#### Objections Under Section 112

Fig. 1

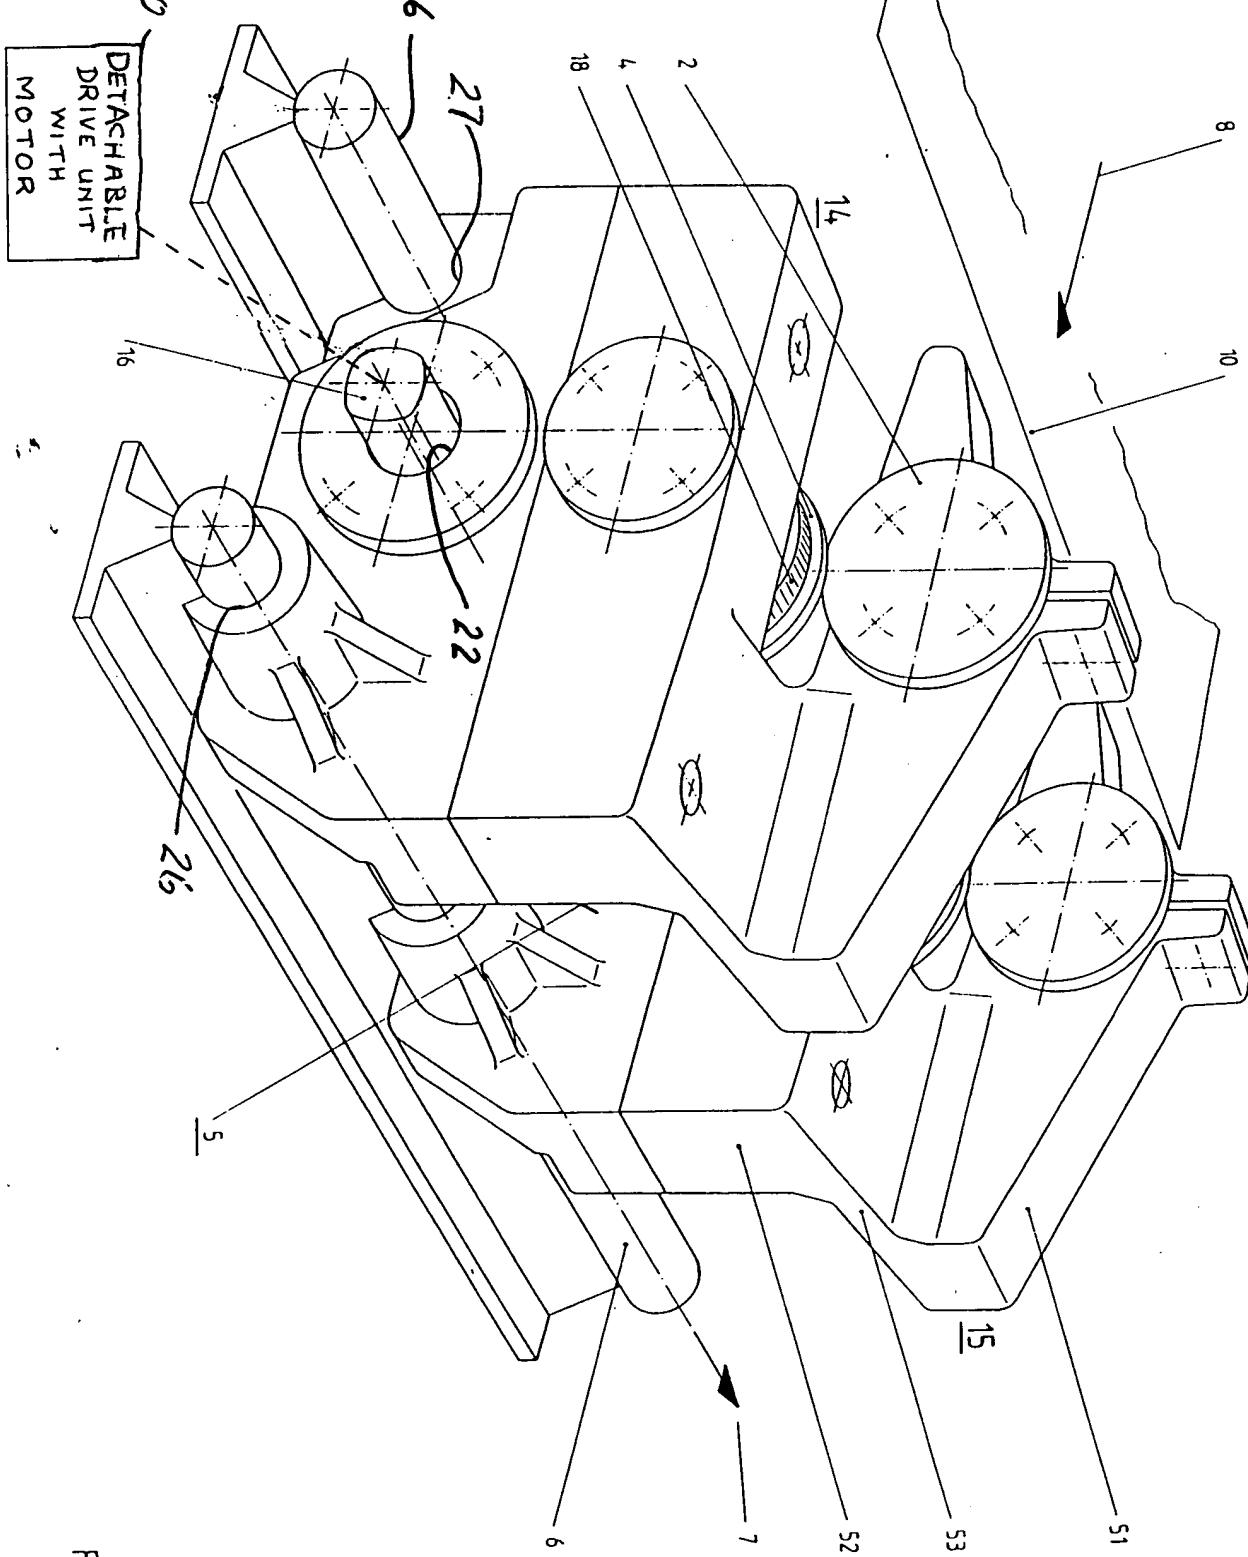
With respect to the adjustment of the cutting gap on page 7 of the specification, the slot through which a pin wrench is inserted as illustrated in Fig. 4 could extend into one or both of the protuberances shown in Fig. 1, but the slot is a circumaxial slot, not the axial slot noted by Examiner in Fig. 1. The circumaxial slot is not visible in Fig. 1 since Fig. 1 is not intended to show a significant level of detail. Furthermore, the circumaxial slot could also extend into or totally occupy the space hidden behind the cutting blade 2 in Fig. 1.

shaft 16. Such drive unit could be uncoupled by splines, cogs, a dog clutch, a belt and pulley and any number of other disengagable drives. For clarity Applicant has amended the illustration of the drive unit 30 in Fig. 1 to indicate that it is detachable as described in the specification on page 6, line 25.

Fig. 2

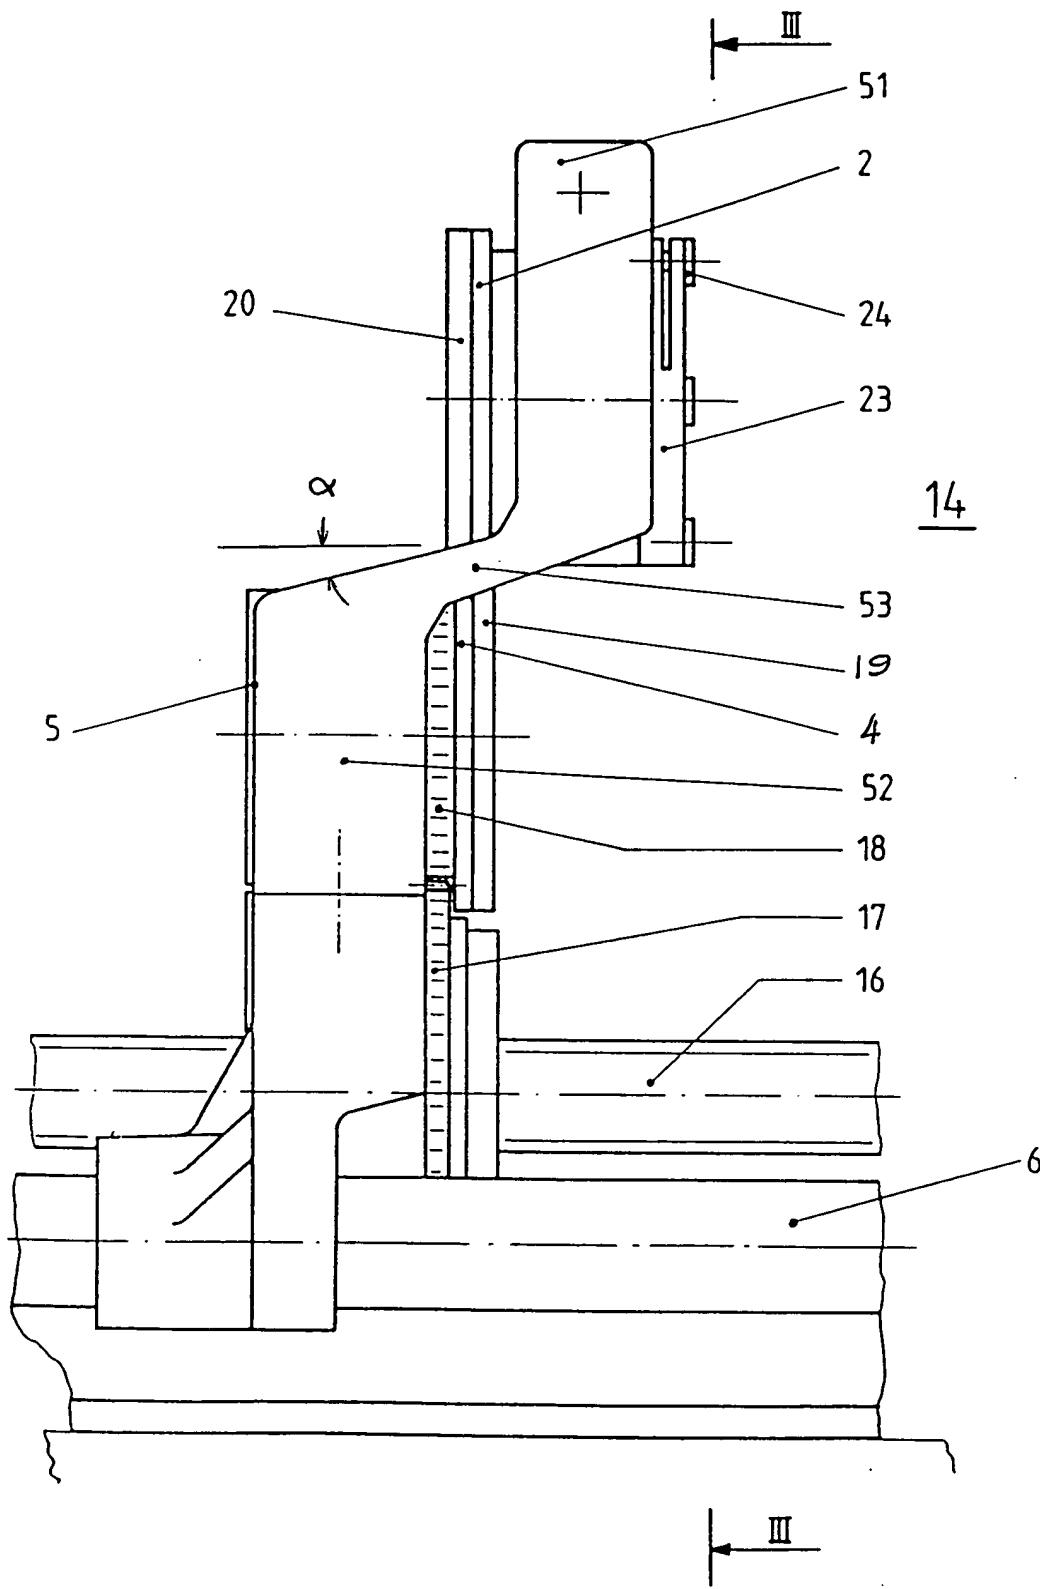
The reference to an acute angle in line 14 of claim 1 is believed to be clear and unambiguous. The angle  $\alpha$  is now illustrated in Fig. 2 as amended. Examiner's question concerning "parallel or perpendicular to the horizontal plane" is not understood. It is axiomatic that the angular relationship between two intersecting planes is defined by the angle subtended by lines in the planes extending perpendicular to the intersection of the two planes.
